**ADDENDUM
NO. 4**

October 9, 2024

**LOWELL HIGH SCHOOL NATATORIUM ADDITION
AND RELATED WORK**

ADDENDUM FOUR

GIBRALTAR DESIGN SHEET
B EP102

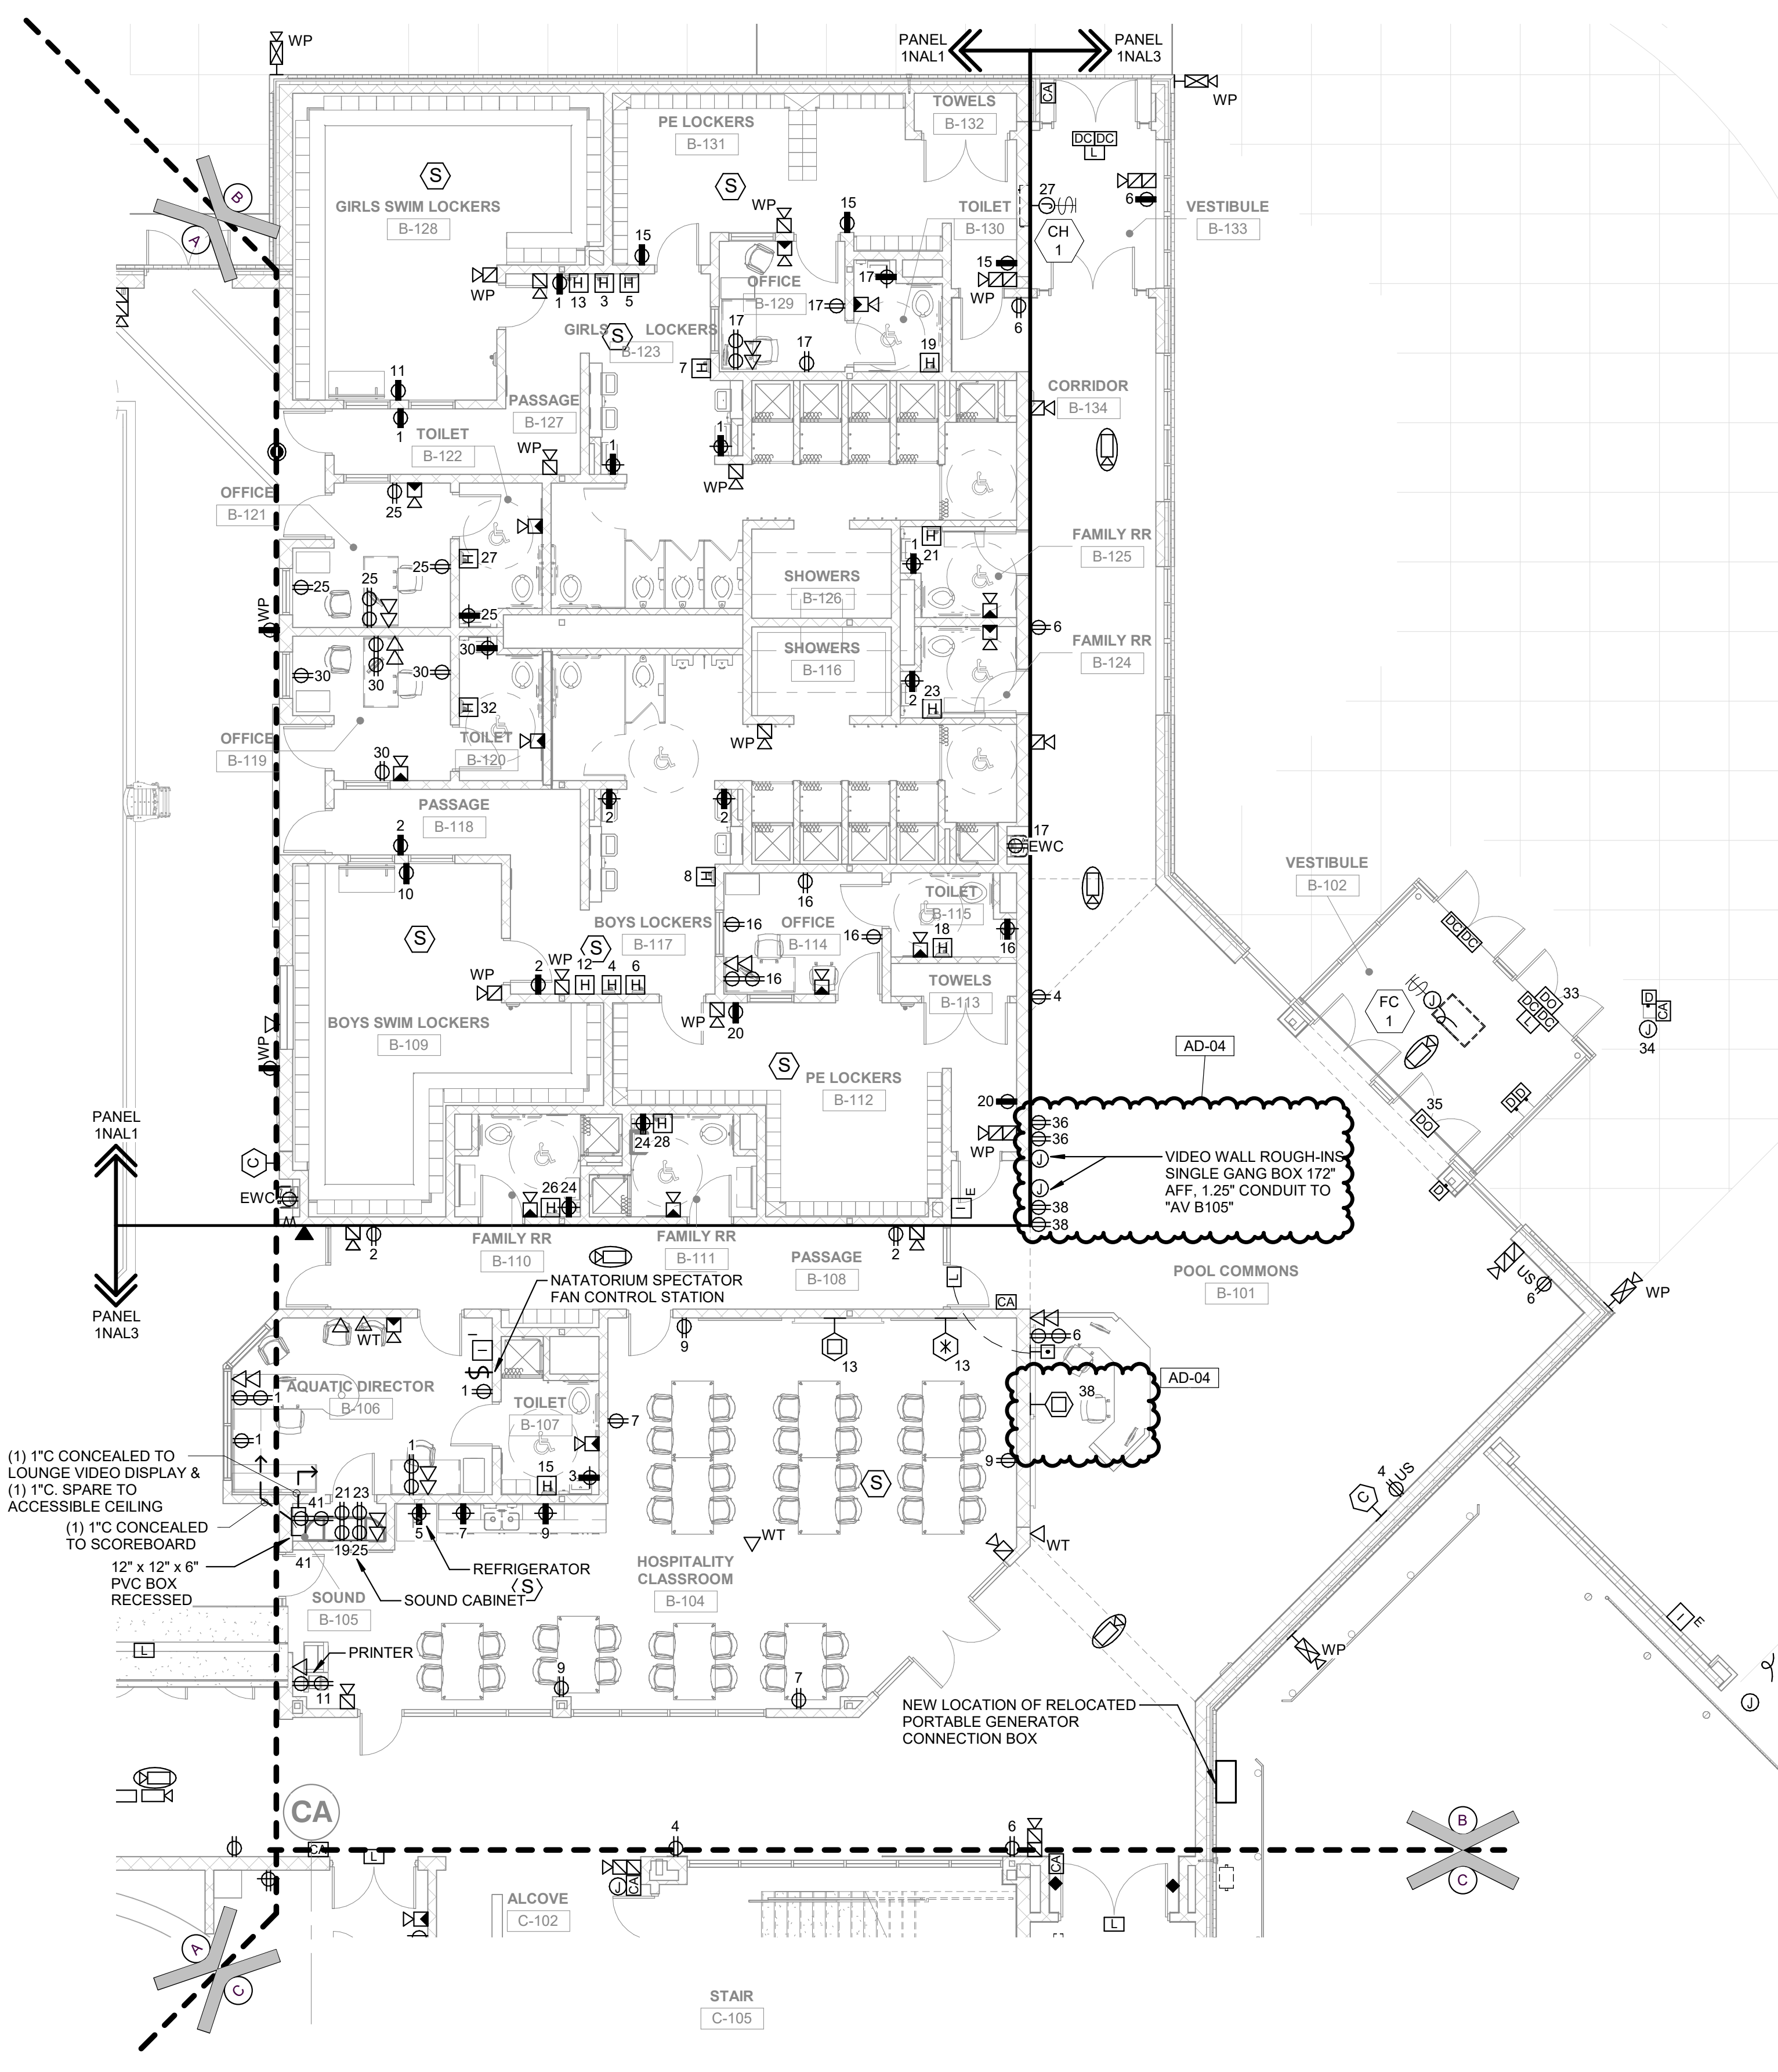
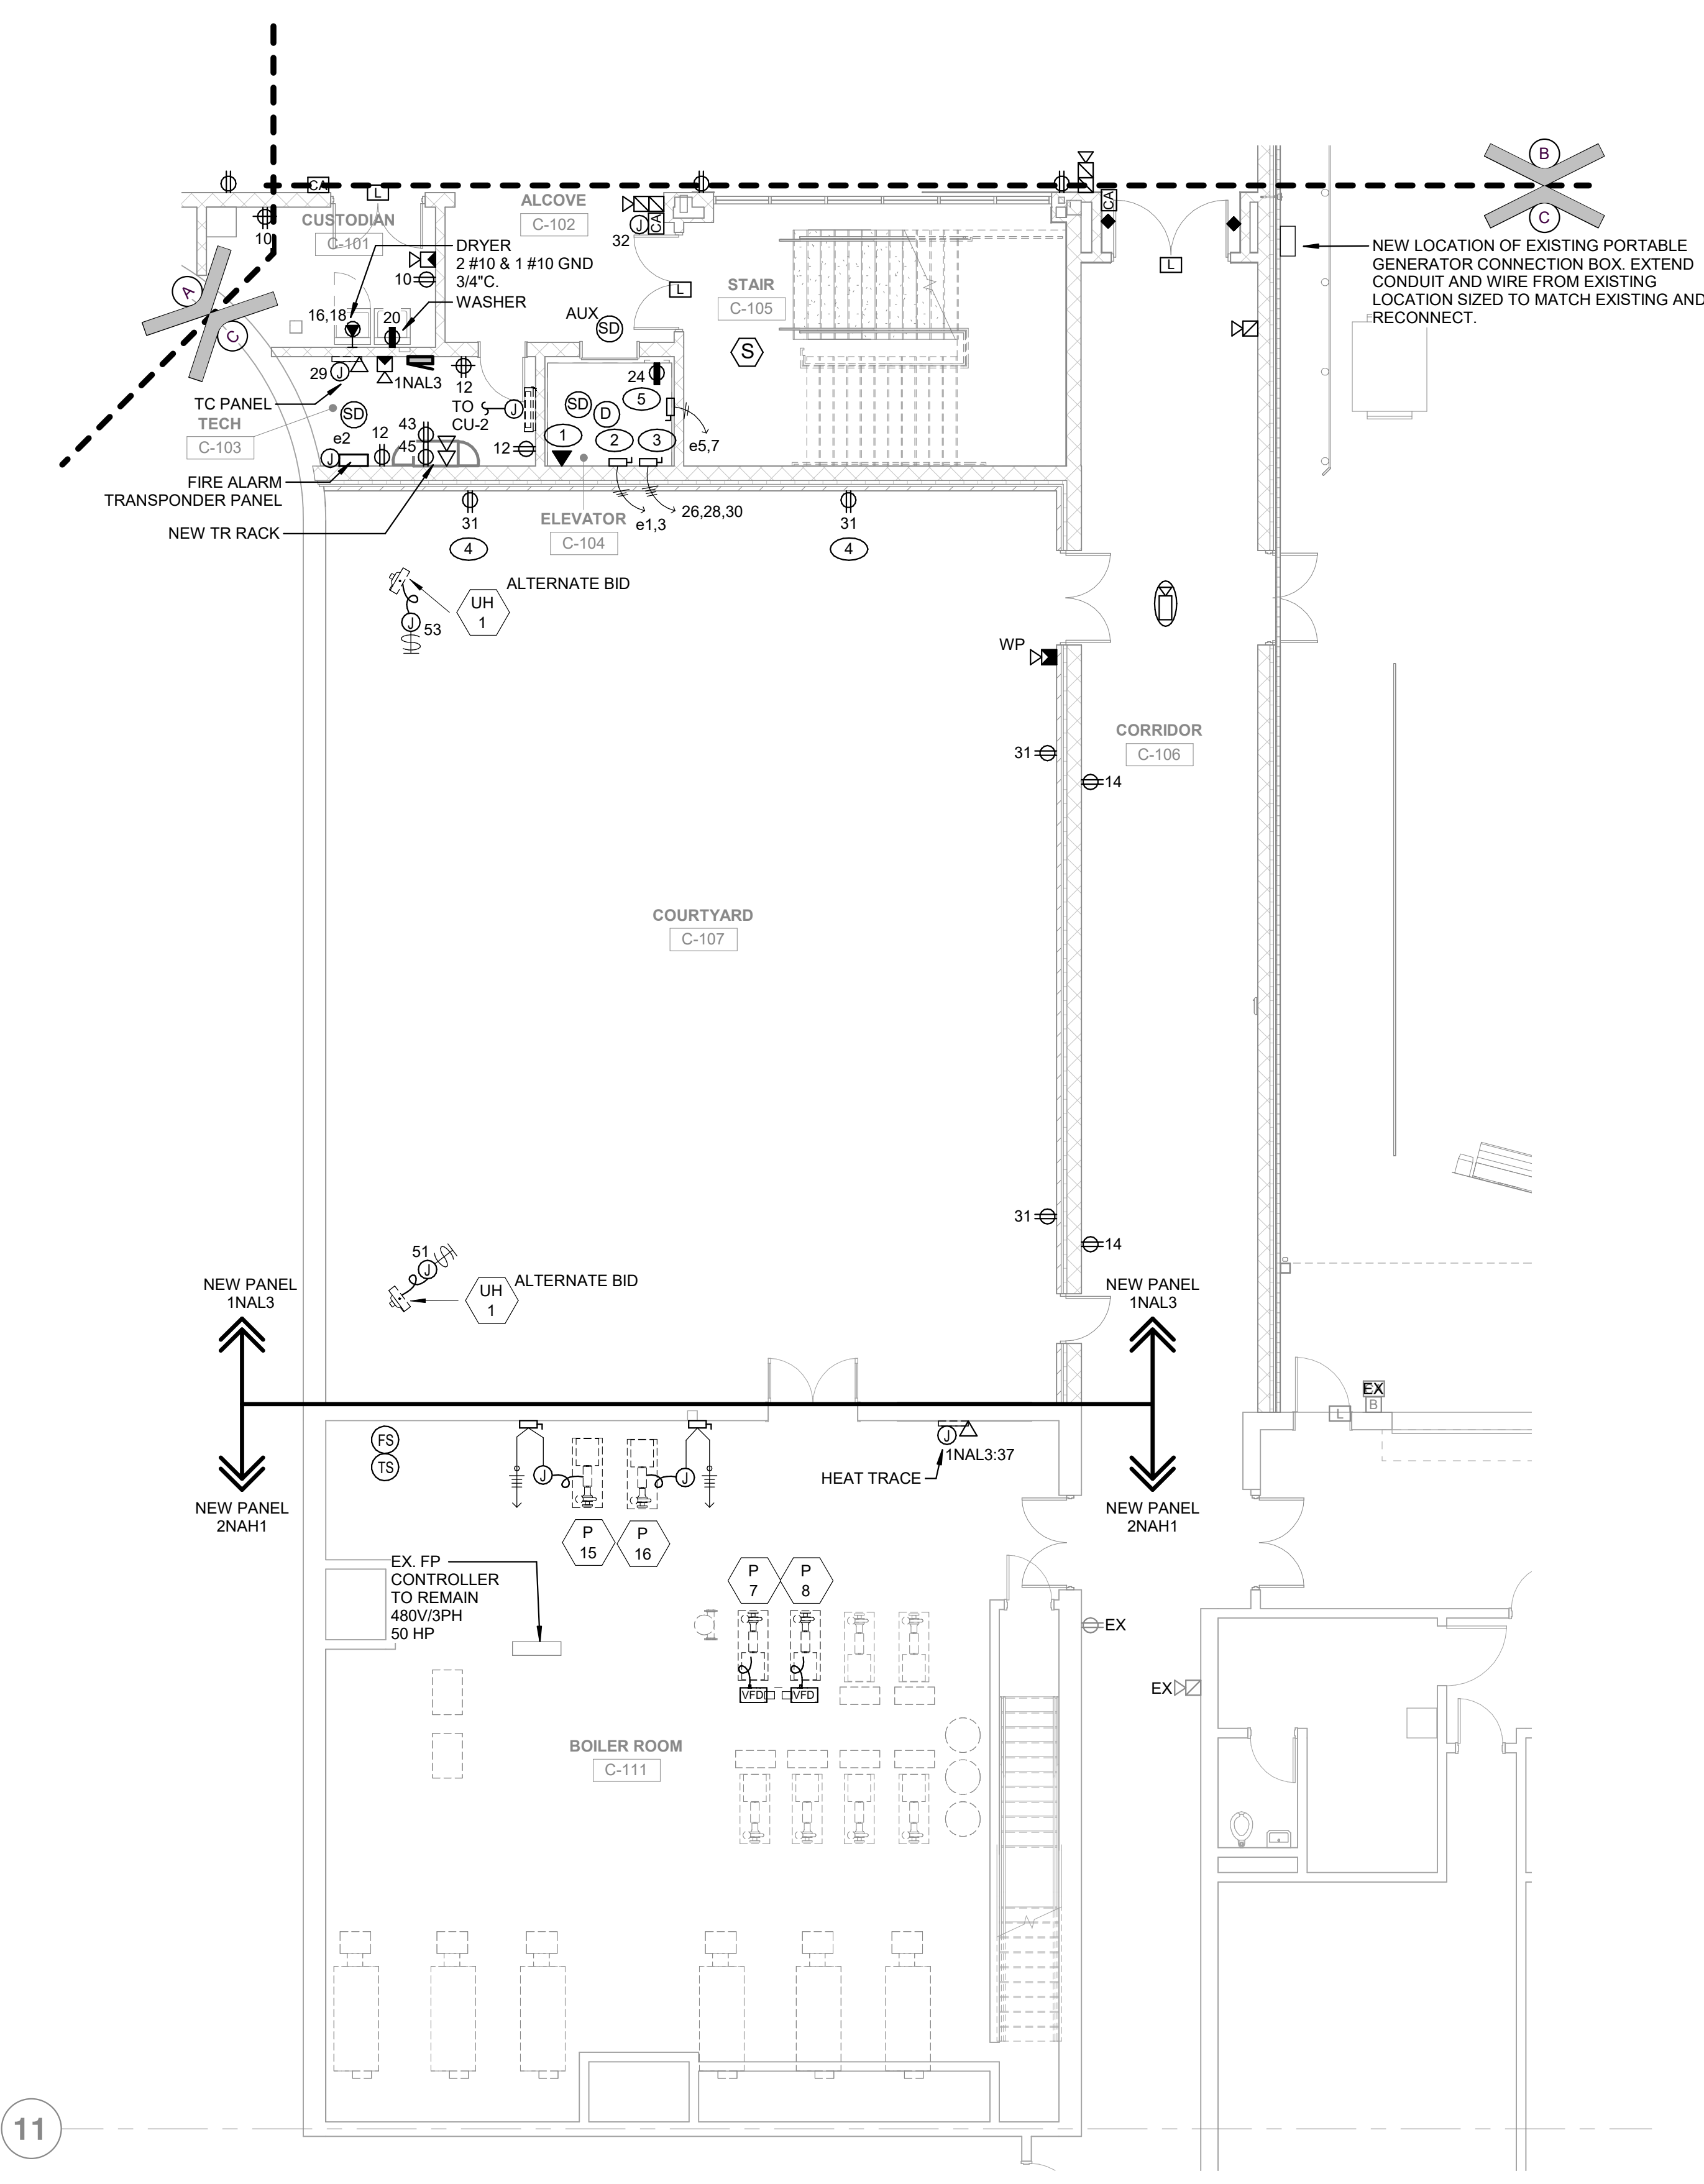
5. Sheet EP102

- A. Refer to revised full size sheet included in this addendum for the following revisions.
 - 1. Revised display locations in commons.
